UNITED STATES  
NUCLEAR REGULATORY COMMISSION  
WASHINGTON, D. C. 20555

SUBJECT: FOLLOWUP EVALUATION TO BOARD NOTIFICATION  
BN-83-21 FOR TMI-1

## ENCLOSURE

Figure 1 NUCLEAR ONCE-THROUGH STEAM GENERATOR (OTSG)  
(From Reference 1)

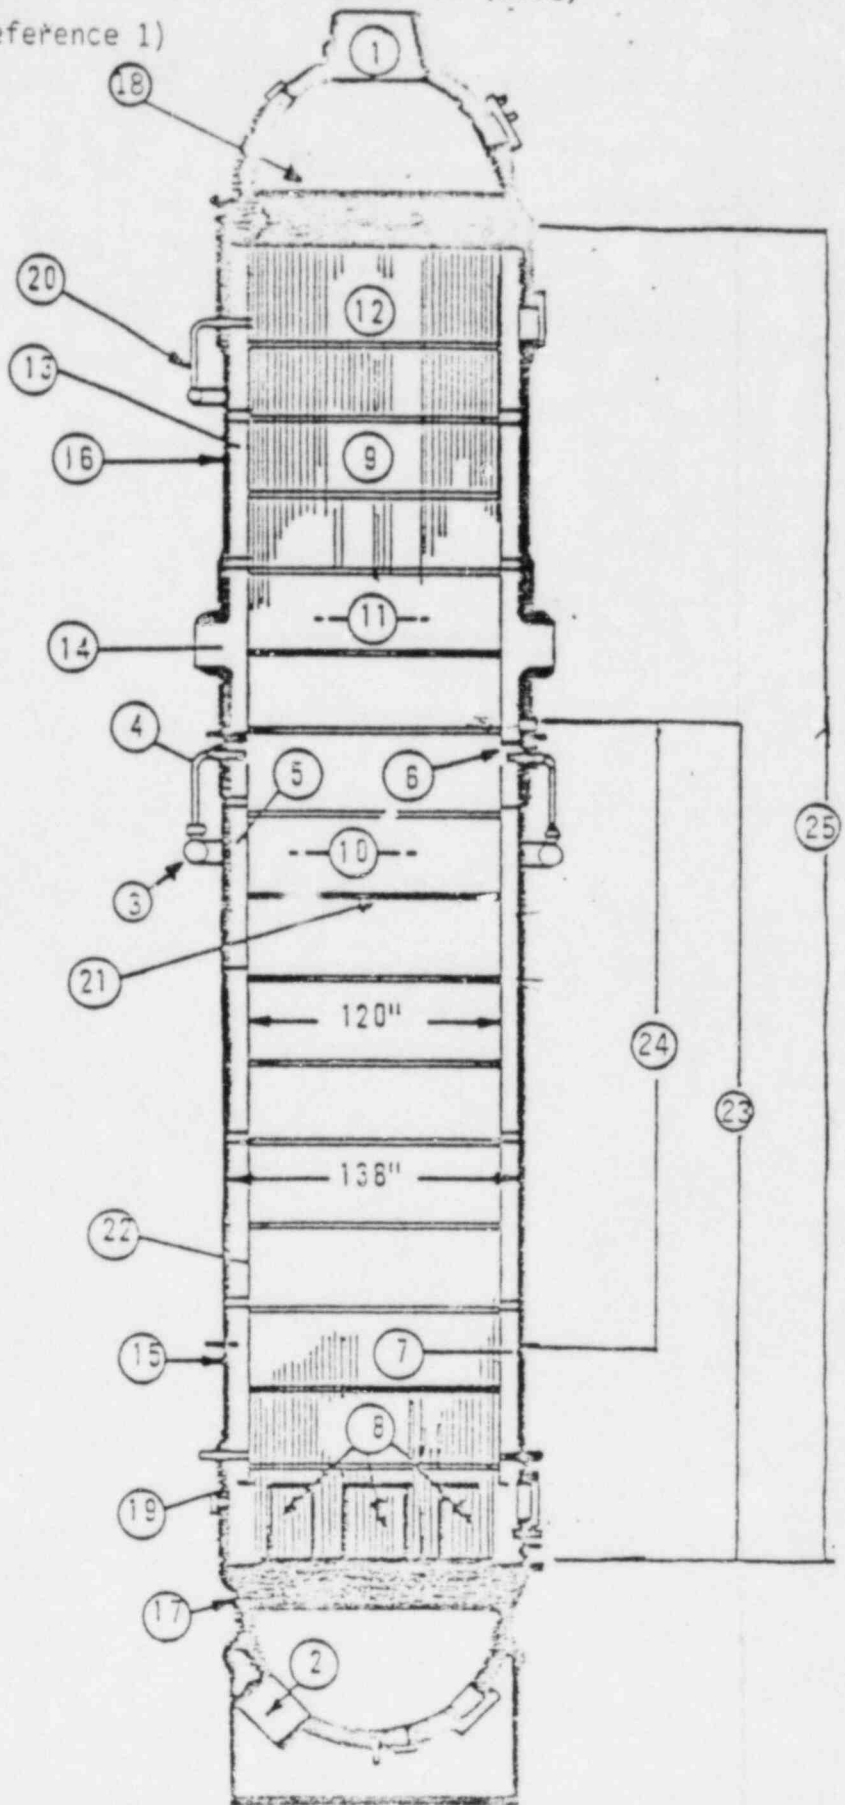
In the Once-Through-Steam-Generator (OTSG) design for the 177-Fuel Assembly plants, emergency feedwater enters the steam generator through seven nozzles located circumferentially around the OTSG shell and at an elevation just above the top tube support plate. This is shown in Figures 1 and 2, taken from the B&W report. Also shown on Figure 1 is the operating range for feedwater level (item 24).

Figure 3 EFW AXIAL WETTING PROFILE  
 (OCONEE 1 - 1B OTSG)  
 (From Reference 1)

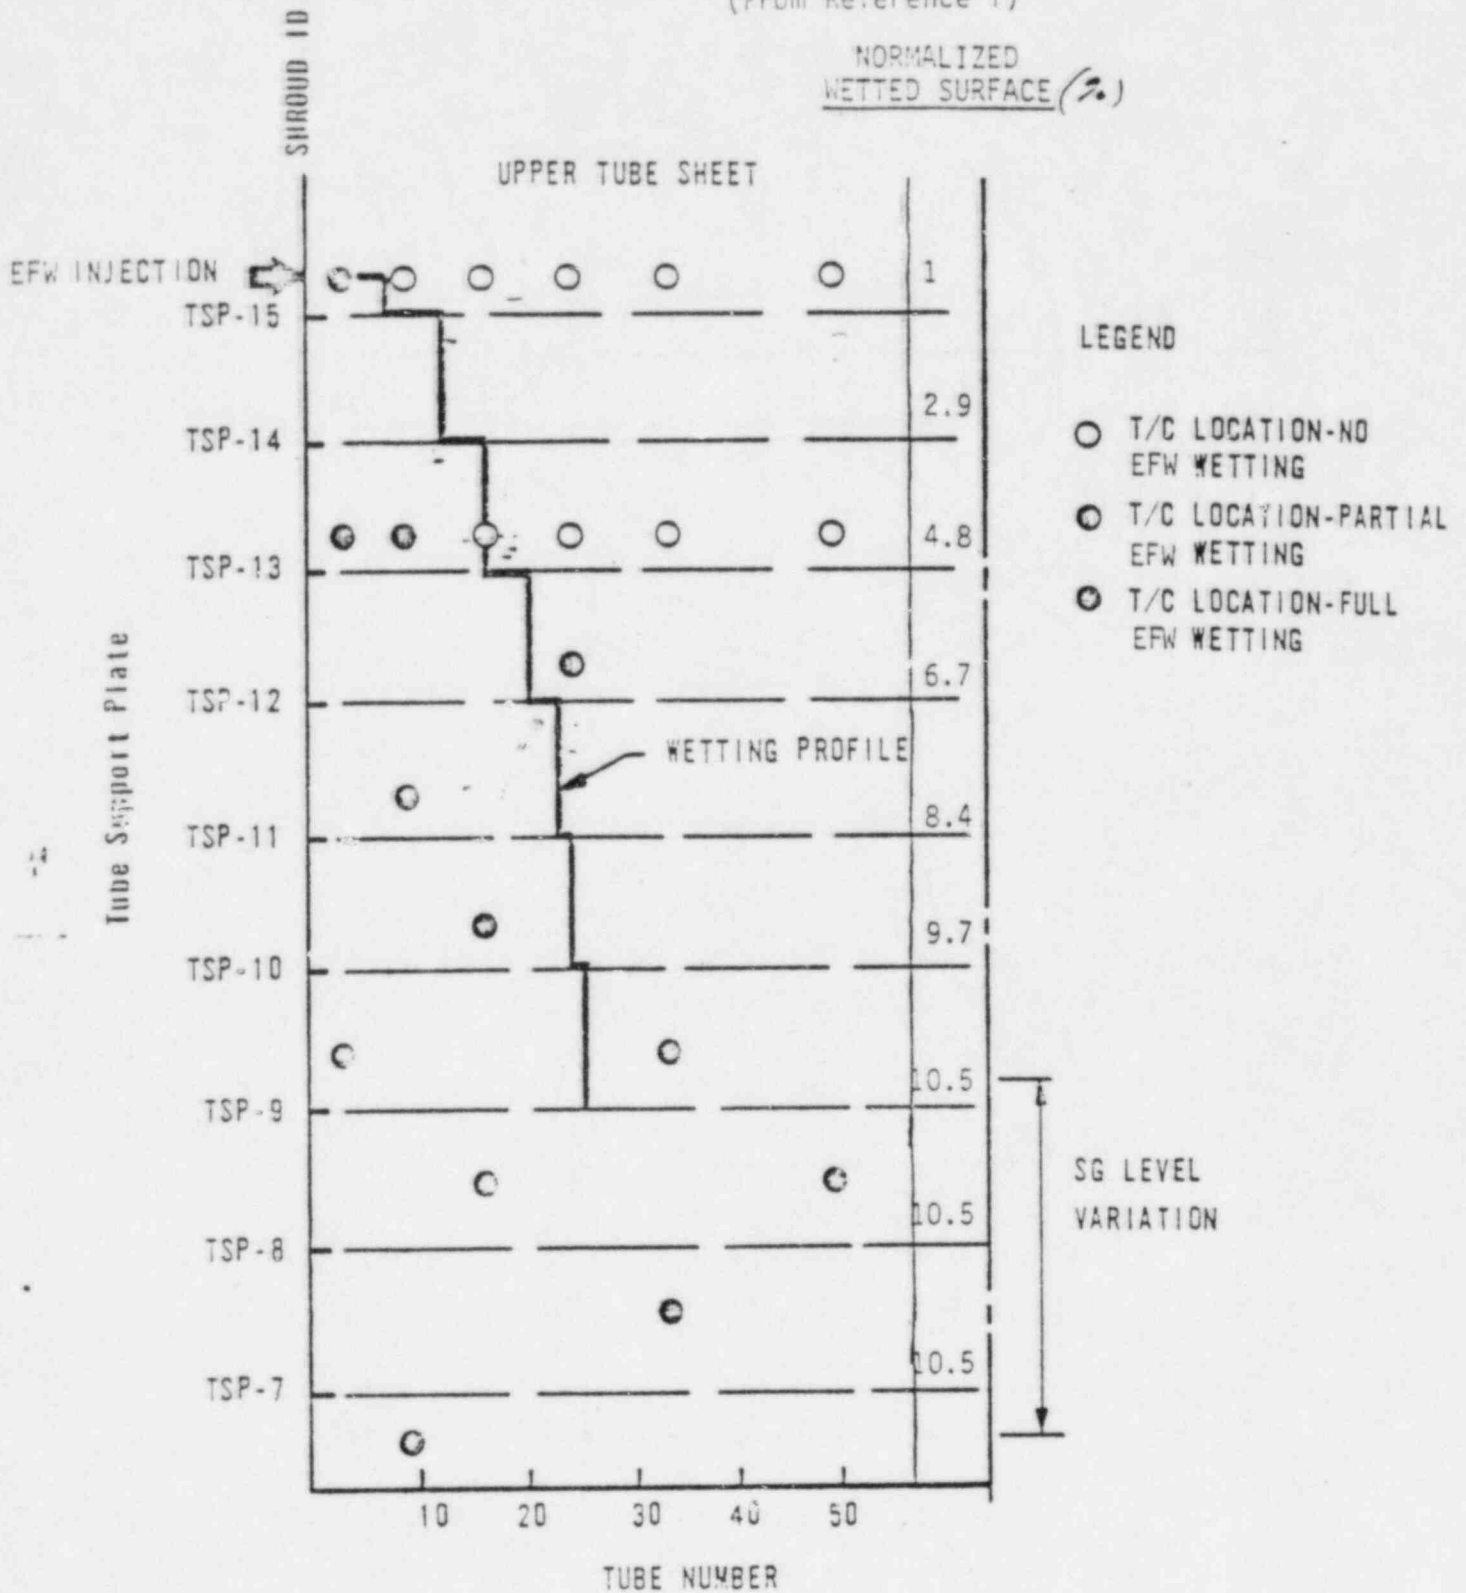
Analysis models used by B&W and the staff have assumed that emergency feedwater injected at the sparger elevation would be uniformly distributed within the tube bundle and provide effective heat transfer to all tubes within the bundle. Data obtained from testing performed by B&W at its Alliance Research Center (ARC) shows however, that the emergency feedwater spray does not effectively penetrate the tube bundle providing uniform wetting and uniform heat transfer throughout the bundle. Rather, the emergency feedwater will only contact those steam generator tubes in the immediate vicinity of the injection nozzle. The emergency feedwater would then pool on the tube support plate and spread out, draining down the flow tube where the tubes penetrate the tube support plate. As can be seen from Figure 1, at least 6 tube support plates exist between the injection location and the top of the operating range. In Figure 3, B&W shows the emergency feedwater axial wetting profile measured in Ocone 1. This shows that as the emergency feedwater drains down the tube bundle, the tube support plates tend to spread the flow towards the center of

the tube bundle. The wetting profile could be envisioned as an "inverted cone." The impact of this incomplete wetting of the tubes is that the heat transfer rates attributed to spray cooling above the secondary side pool level can be reduced from what they were originally, based on the 100 percent wetting assumption.
